50 West Di Lido Drive

DRB25-1112

October 23, 2025

Impacted Property

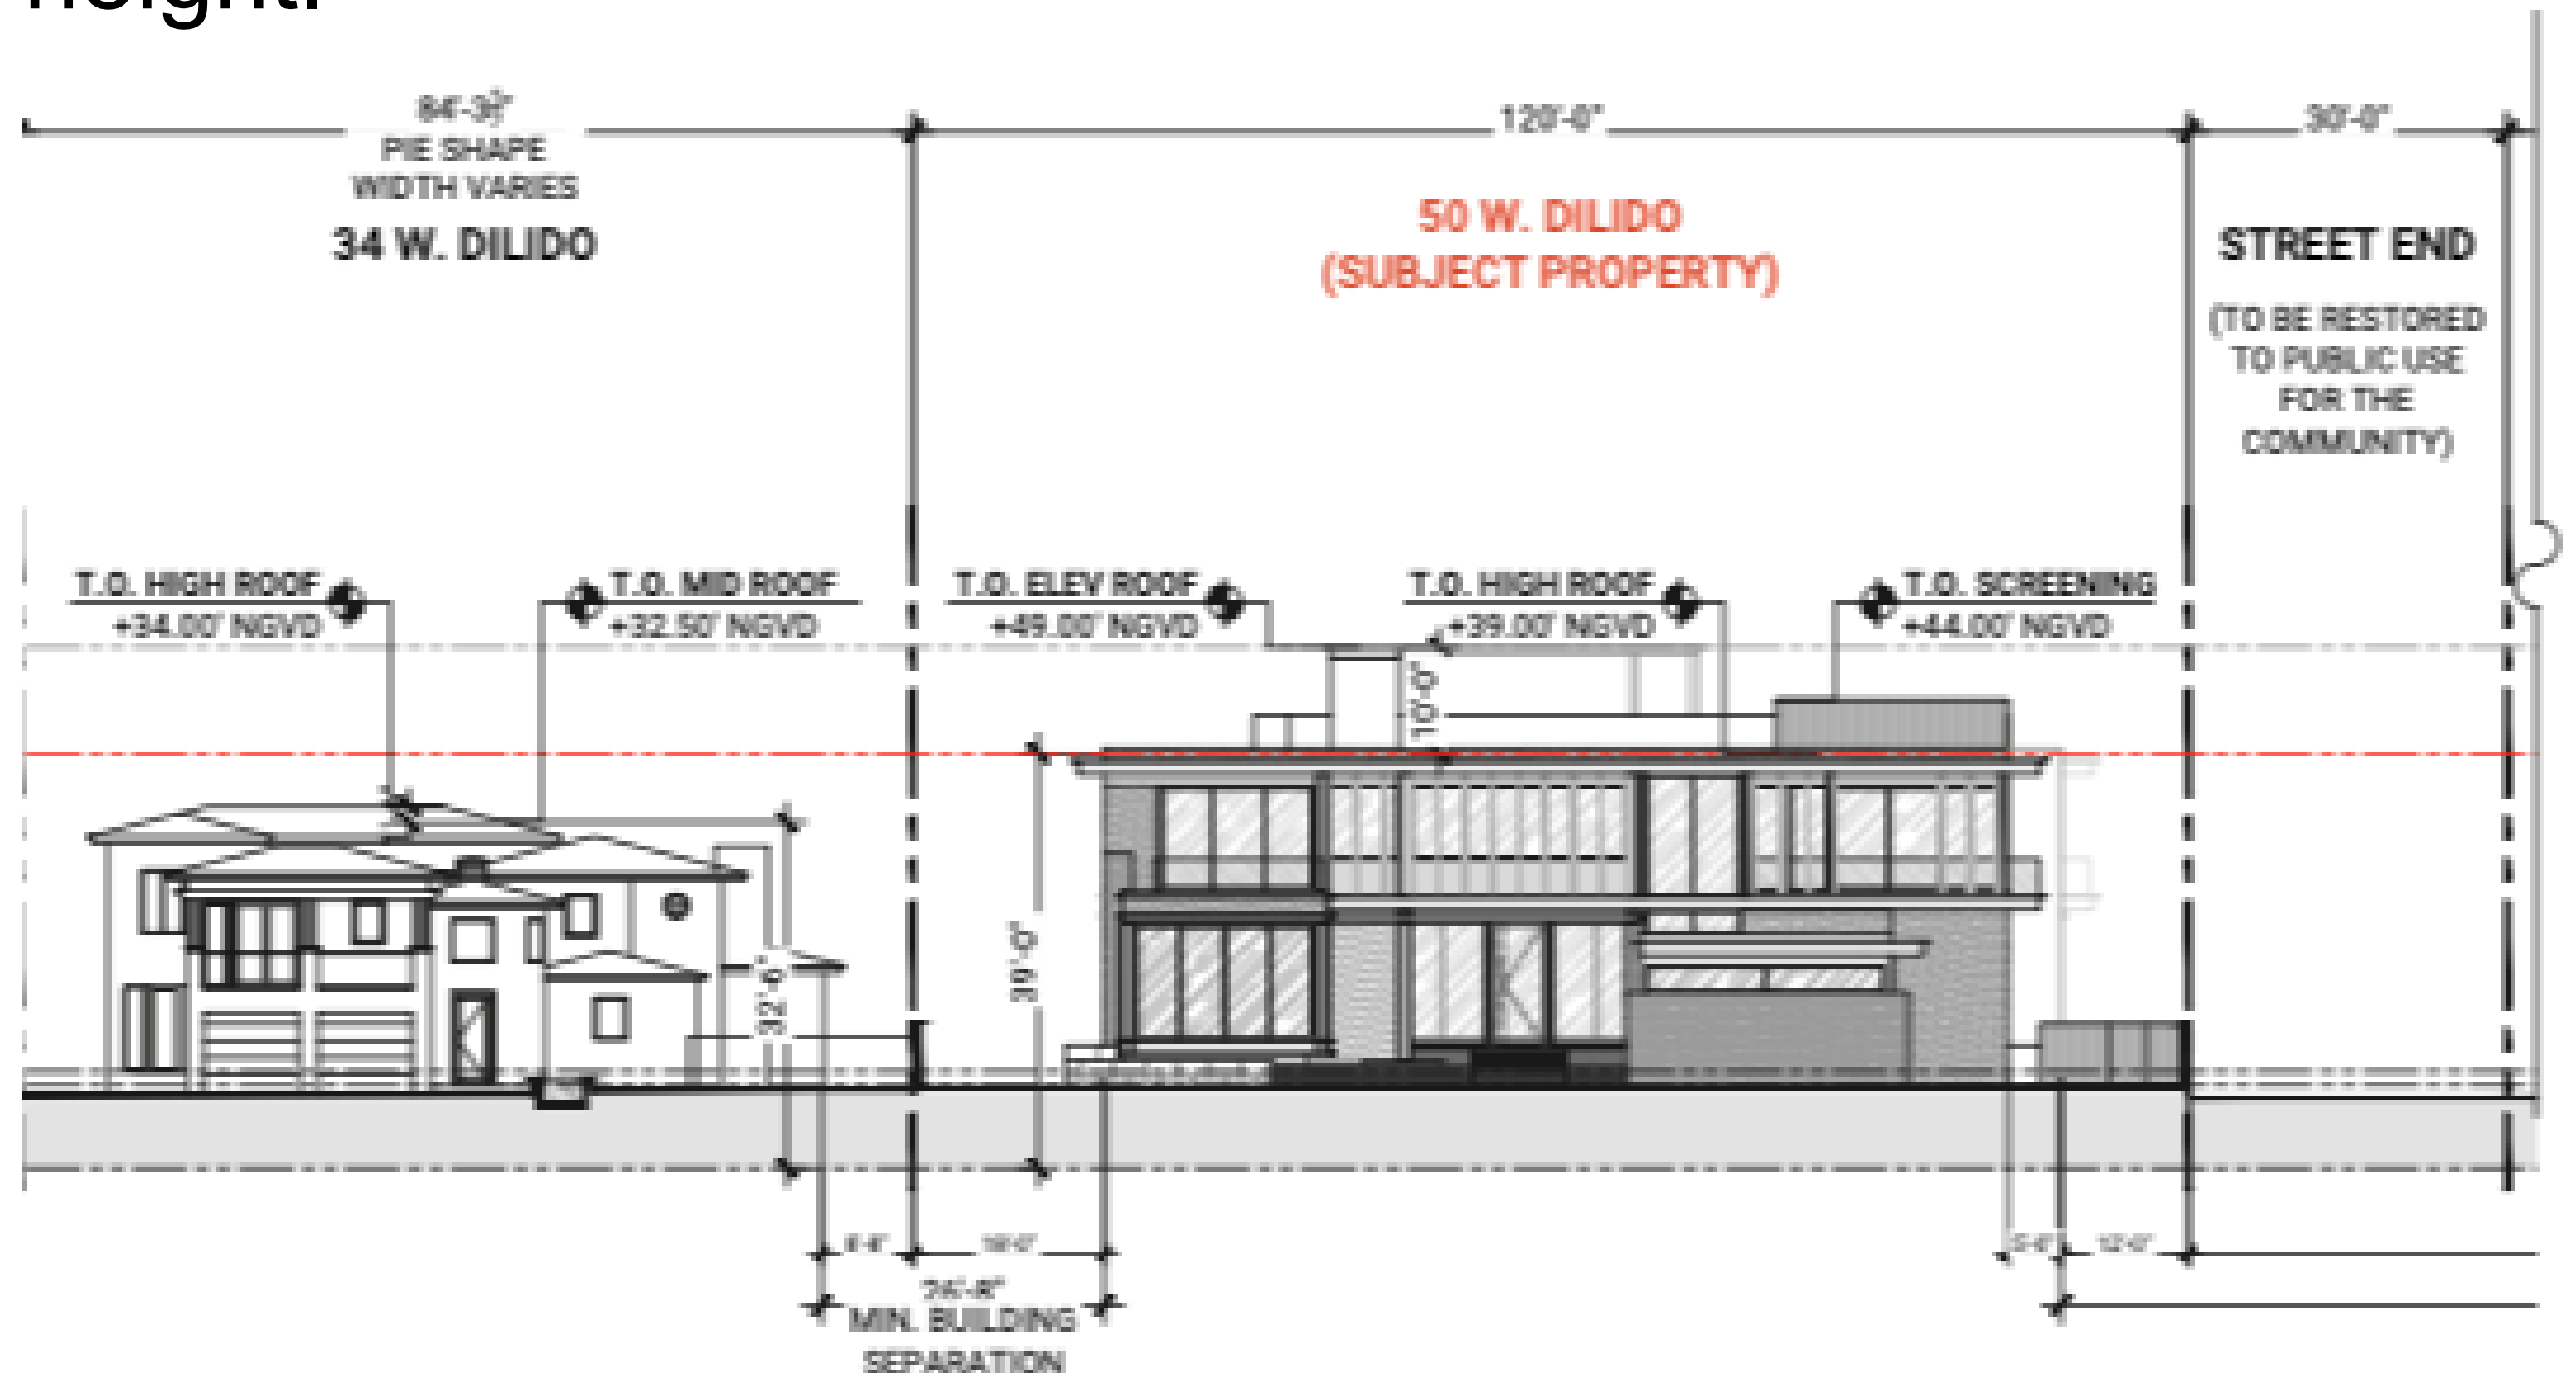
- 34 W Di Lido Drive
- Krieger Family Home since 1987
- 5,400+/- sq ft

- The maximum building height for flat roofs in the RS-3 zoning district, as measured to the top of slab of the roof, is 24'-0".
 - The dimensions of all buildings, structures, setbacks, parking spaces, floor area ratio, height, lot coverage and any other information that may be reasonably necessary to determine compliance with the requirements of the underlying zoning district

- *However*, in the RS-3 zoning district the DRB may approve an additional 3-feet of height.
 - The proposed structure, or additions or modifications to an existing structure, indicates a sensitivity to and is compatible with the environment and adjacent structures, and enhances the appearance of the surrounding properties.

- The applicant is seeking the additional 3'-0" in order to construct the main home at a height of 27'-Approval ... *even though the Applicant has admittedly failed to satisfy the mandated minimum requirements 0"*.

- The proposed structure has an orientation and massing which is sensitive to and compatible with the building site and surrounding area
- Approval
 - ... *even though the Applicant has admittedly failed to satisfy the mandated minimum requirements 0"*.

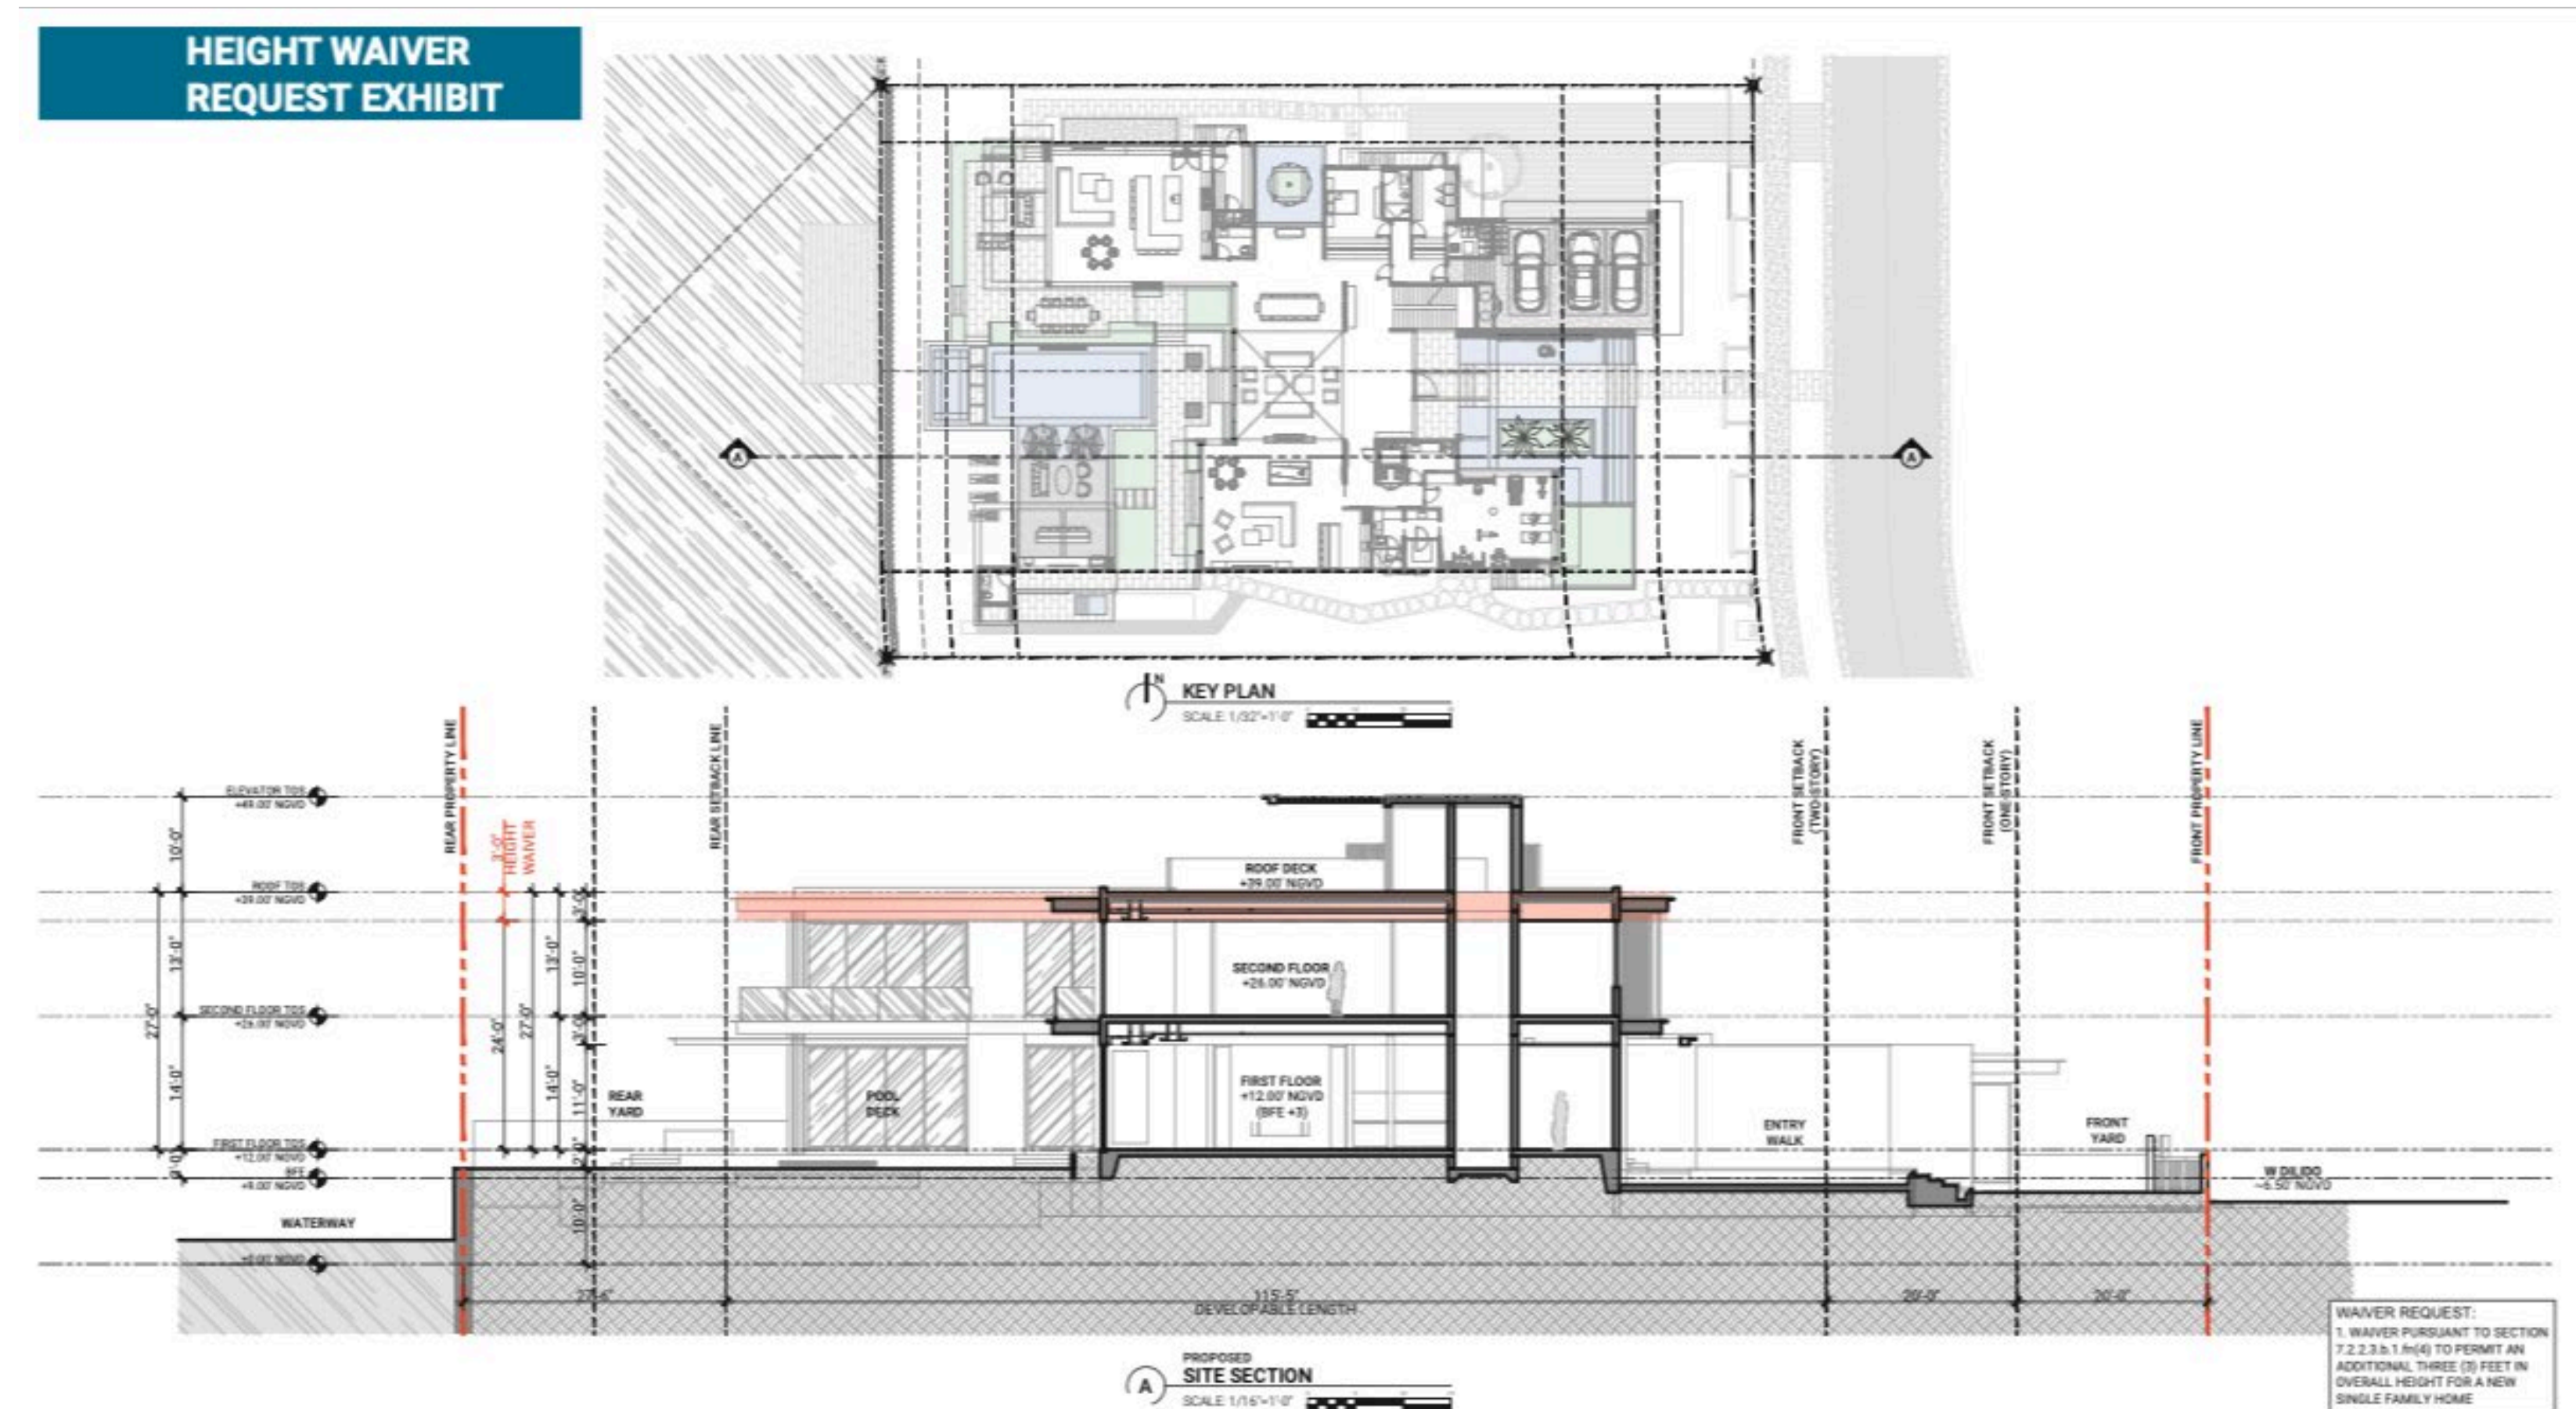
- The intent is to push the massing closer to the thirty (30) foot platted public space abutting the Property.
- The abutting residential home is recognized as the most sensitive existing improvement within the surrounding community.
- **Design review encompasses the examination of architectural drawings for consistency with the criteria ... with regard to the aesthetics, appearance, ... and physical attributes of the project in relation to the site, adjacent structures and surrounding community.**

- The proposed structure, or additions or modifications to an existing structure, **indicates a sensitivity to and is compatible with the environment and adjacent structures, and enhances the appearance of the surrounding properties.**
